DOCUMENT CHANGE NOTICE (DCN)

DOCUMENT No. (DOC-REV-GP. ID)	TITLE	NEW REV.
D980218-00	I. O. BAFFLE, GLASS, BOTTOM RIGHT	A
D980691-A	I. O. BAFFLE, GLASS, TOP LEFT	B
D980692-A	I. O. BAFFLE, 2K, GLASS, TOP RIGHT	B
D980693-A	I. O. BAFFLE, GLASS, BOTTOM LEFT	B
D980694-A	I. O. BAFFLE, GLASS, TOP LEFT SEGMENT	B
D990617-A	I. O. BAFFLE, 4K, GLASS, TOP RIGHT	B

D980692-B

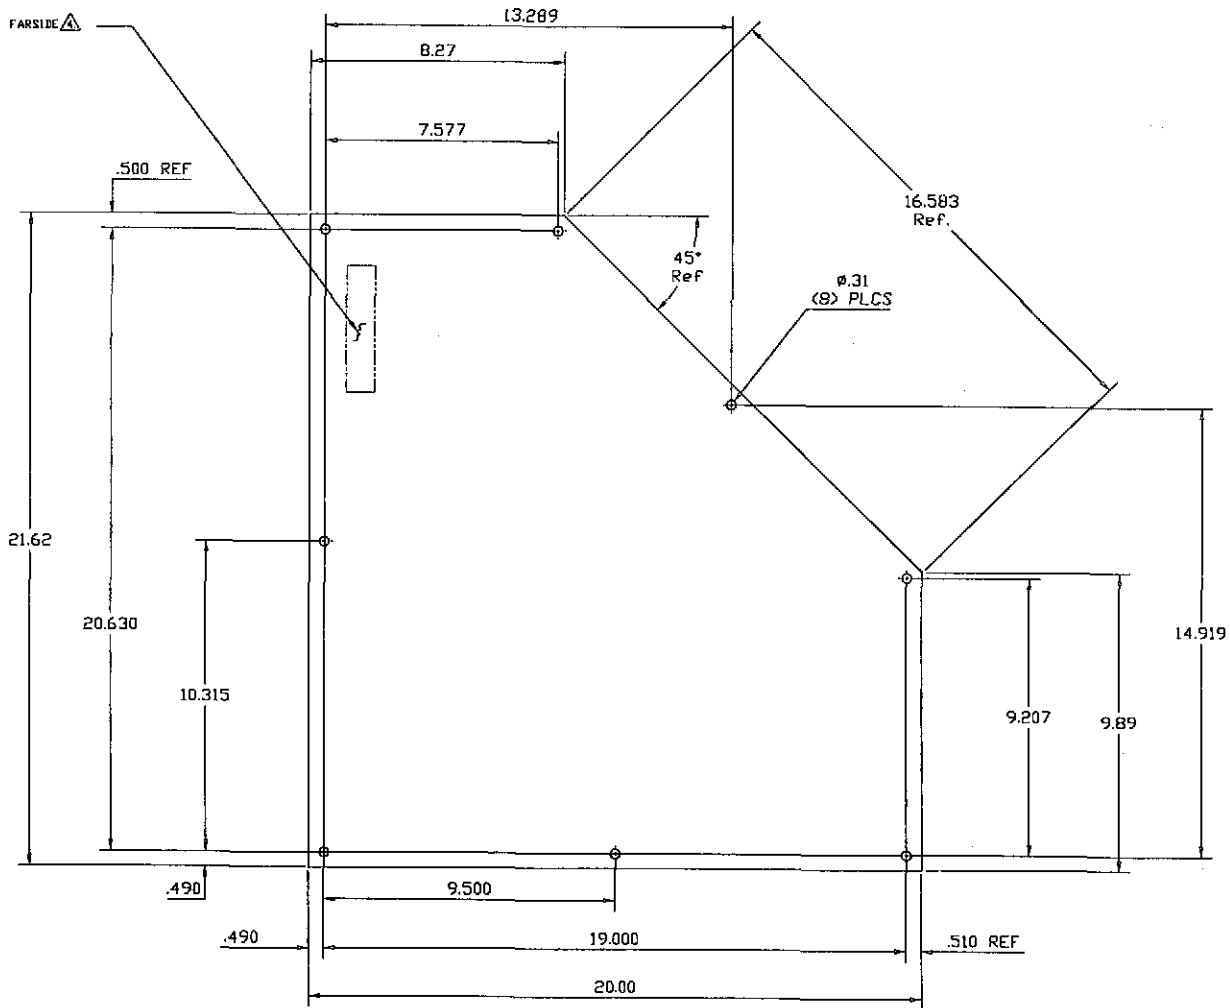
D980691:-B, D980692-B, D980693-B, D990617-B

Re dimensioned to eliminate unnecessary machining of stock surface.

ALL DRAWINGS:

Revised masking note to allow processing from both sides and to assist shipping.

ISSUE NO: **D980693-B**

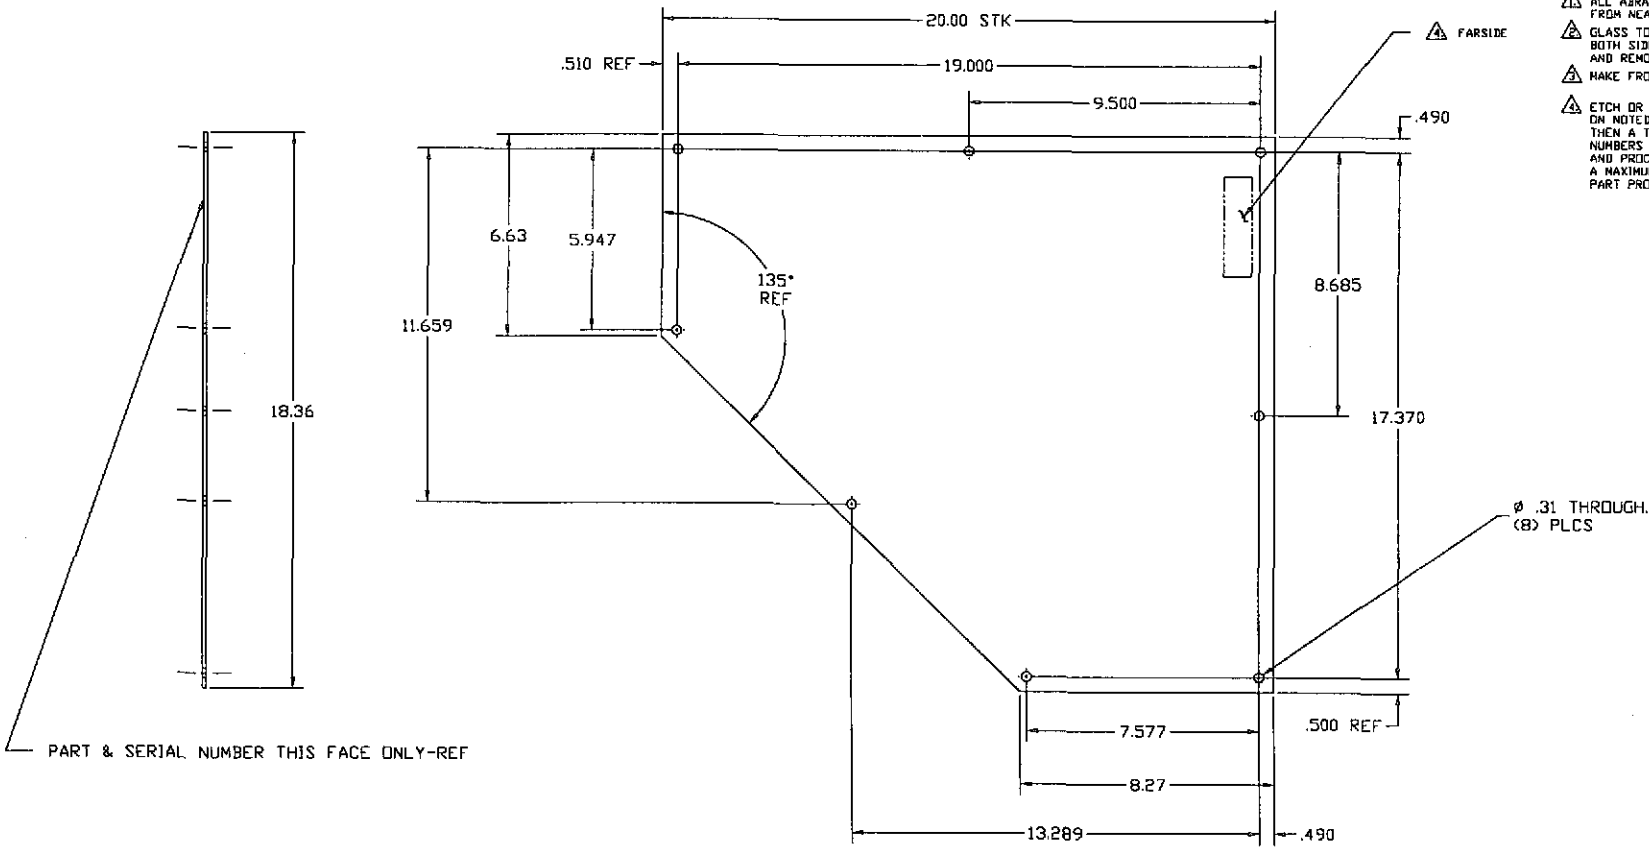
D980693-B:

Modified from multi-use (right hand/left hand) glass plate to left hand only plate.
 Fabrication process requires orientation and marking of back surface.
